FINAL PRODUCT/PROCESS CHANGE NOTIFICATION #16794Generic Copy

Issue Date: 27-Jan-2012**TITLE:** Addition of OSPI manufacturing site for automotive grade Serial EEPROM products in TSSOP 8-pin package.**PROPOSED FIRST SHIP DATE:** 15-Jun-2012**AFFECTED CHANGE CATEGORY(S):** Automotive Serial EEPROM devices using the TSSOP 8-pin package: CAV24CxxYE-GT3; CAV25xxxYE-GT3, CAV93CxxYE-GT3**FOR ANY QUESTIONS CONCERNING THIS NOTIFICATION:**Contact your local ON Semiconductor Sales Office or Denisa Stefan Denisa.stefan@onsemi.com**SAMPLES:** Contact your local ON Semiconductor Sales Office**ADDITIONAL RELIABILITY DATA:** Available upon requestContact your local ON Semiconductor Sales Office or Tony Luciani tony.luciani@onsemi.com**NOTIFICATION TYPE:**

Example:

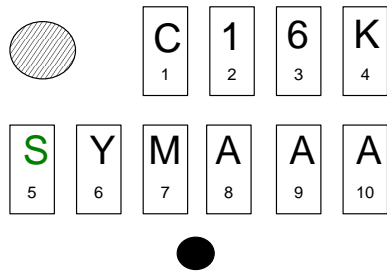
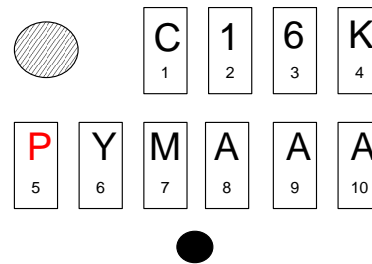
The OSPI manufacturing site is identified by letter “P” for the “Assembly Location Code”: first character, 2nd line of the top package marking.

CAV24C16YE-GT3 at STARS

CAV24C16YE-GT3 at OSPI

Line 1: C16K

Line 2: *YM AAA (*= assembly site code)
